October 12, 2017

*RE: Northern Colorado Constructors, Inc. – Bennett Pit – File No. M-2016-085
112c Permit Application, Third Adequacy Review Response*

Floodplain Study Comments

Slurry Wall Assessment Comments

Floodplain Map - Mining

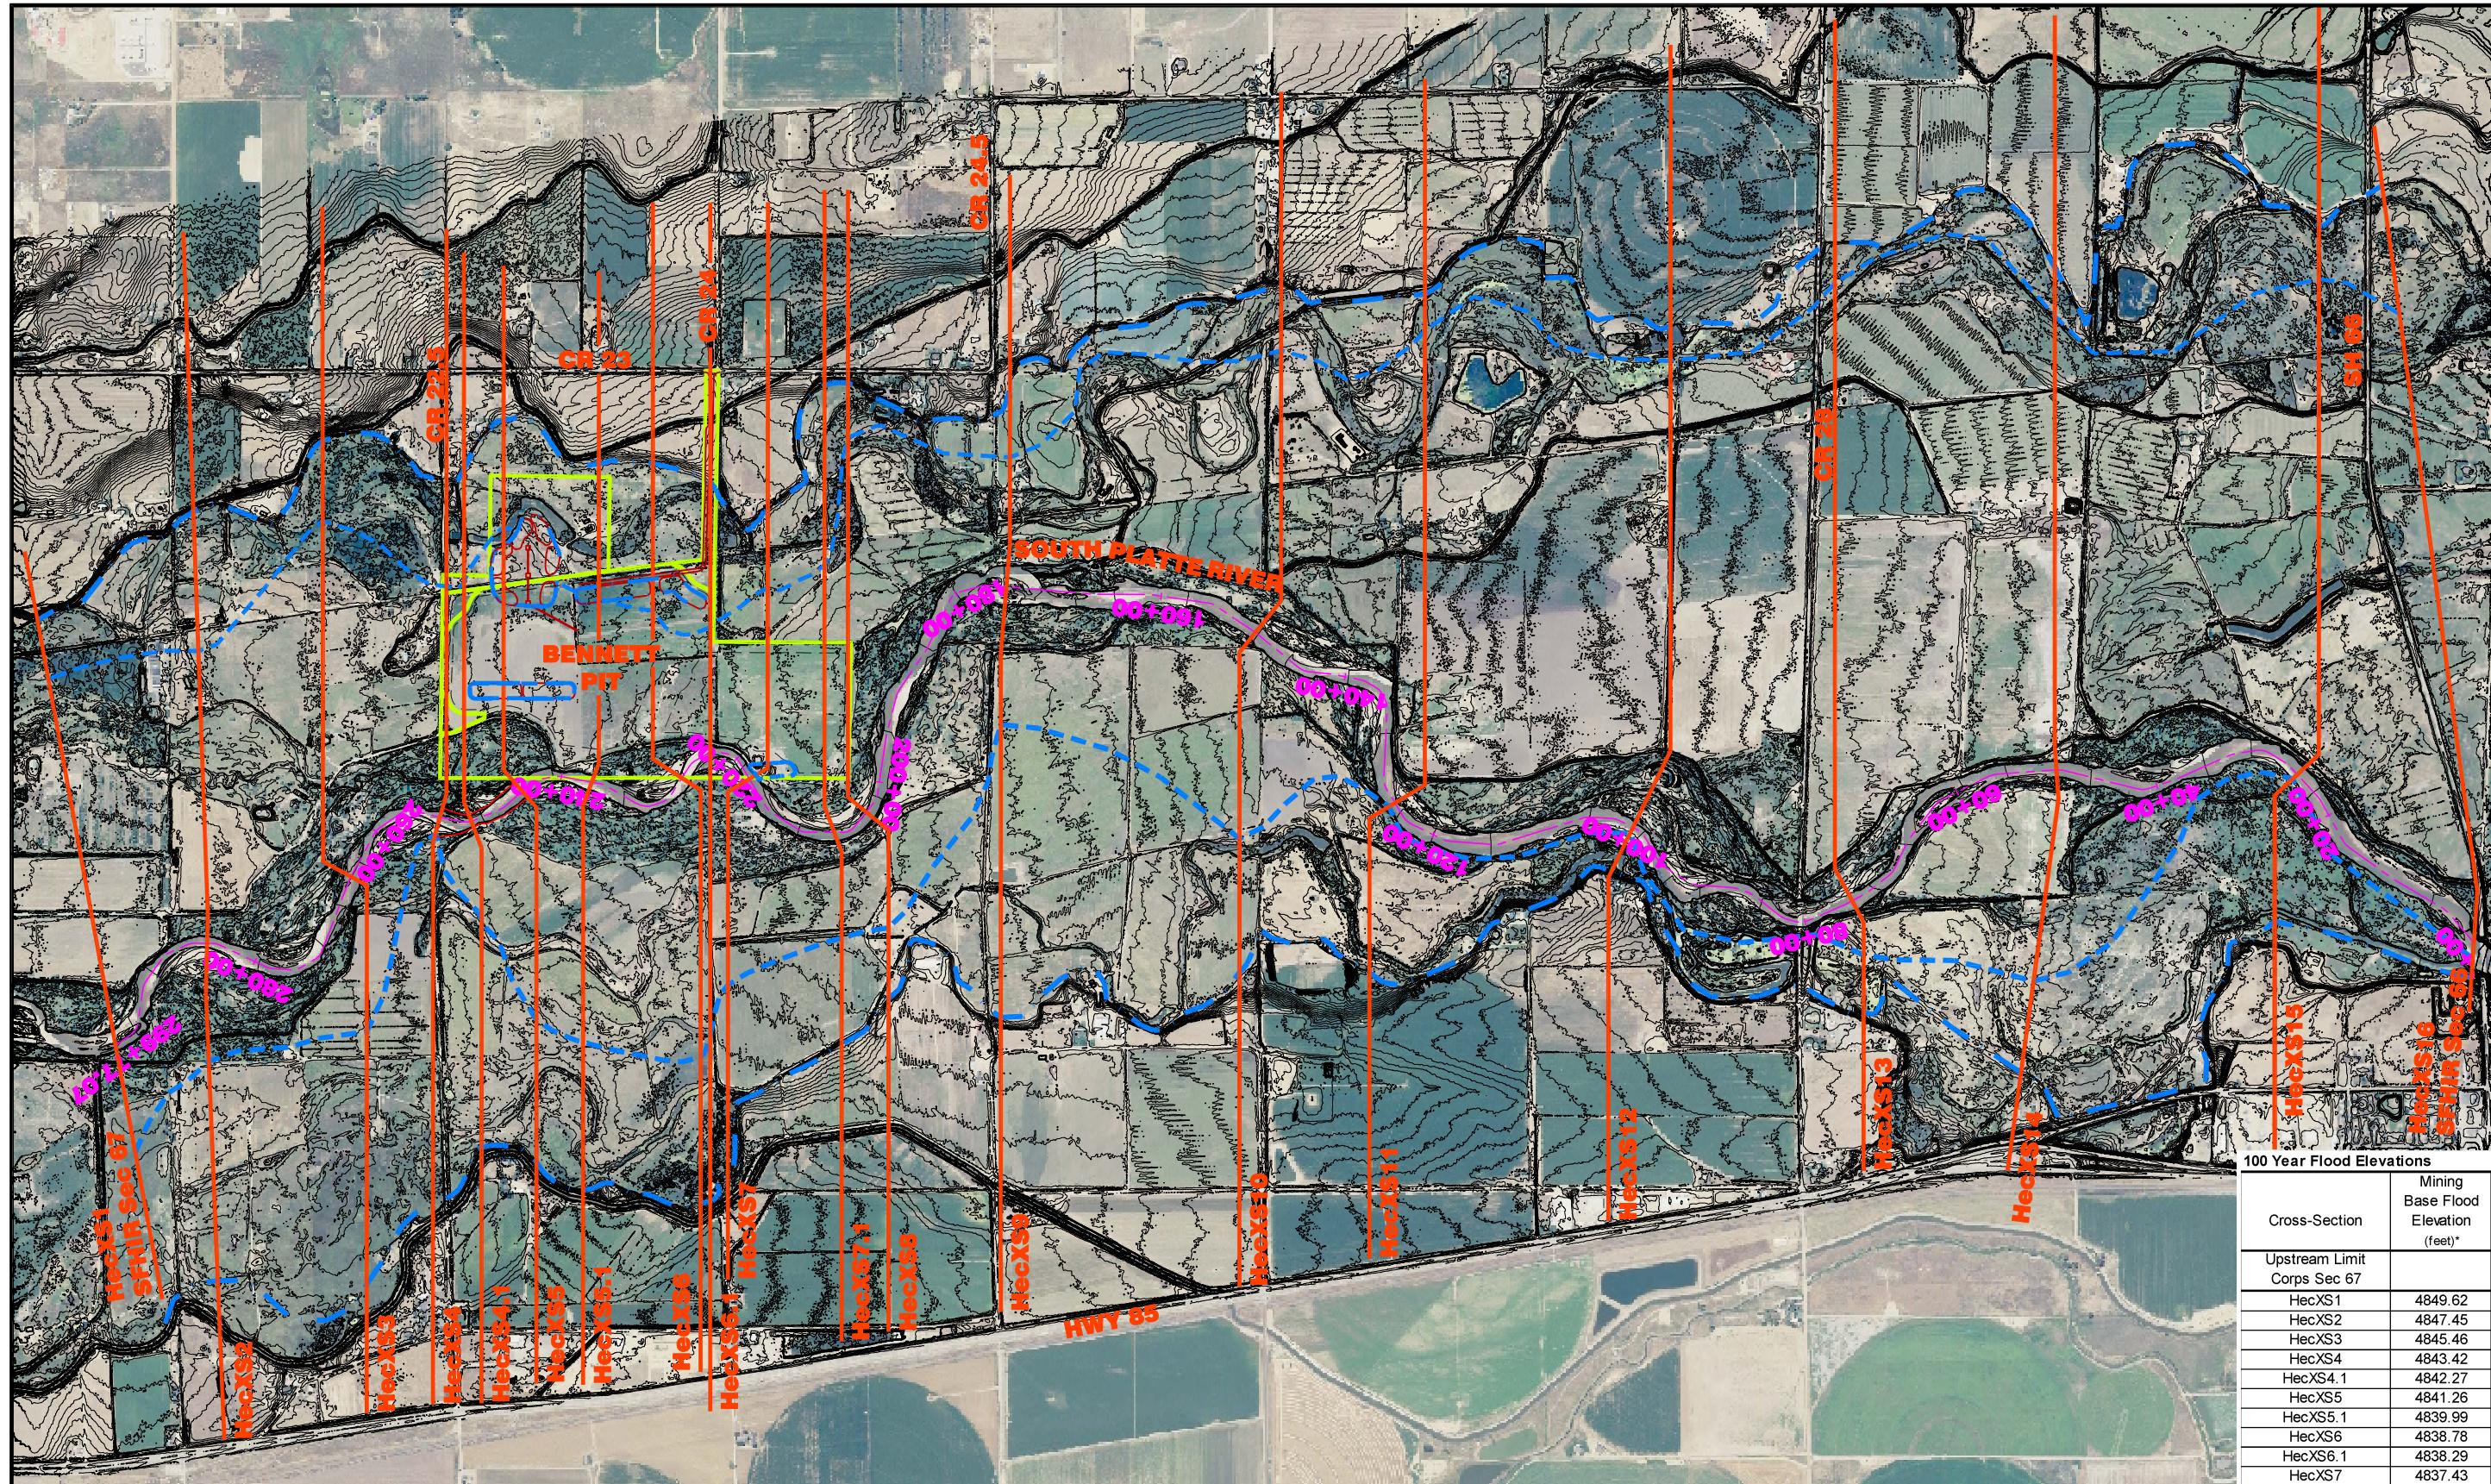
2. Page 1, last paragraph & Page 2 – The text indicates a model was done for existing topography and for future conditions. The Division interprets the future conditions to reflect post reclamation conditions. Please explain why a model was not done for a worst case scenario during operations. This should include maximum expected footprints for topsoil, overburden and product stockpiles, as well as proposed onsite structures such as scales, scale house, offices, etc.

Response: A mining conditions model has been added to the study. Blockouts were added to sections 5, 5.1, and 6 to simulate the stockpiles and scale house during mining conditions. Note that the scale house is located outside the floodplain. The pit areas were assumed to be partially mined, i.e. overburden/topsoil had been stripped and stockpiled and a volume of sand and gravel had been removed equal to the stockpile volumes in the processing area. Additional cross-sections HECXS4.1, HECXS5.1, HECXS6.1, and HECXS7.1
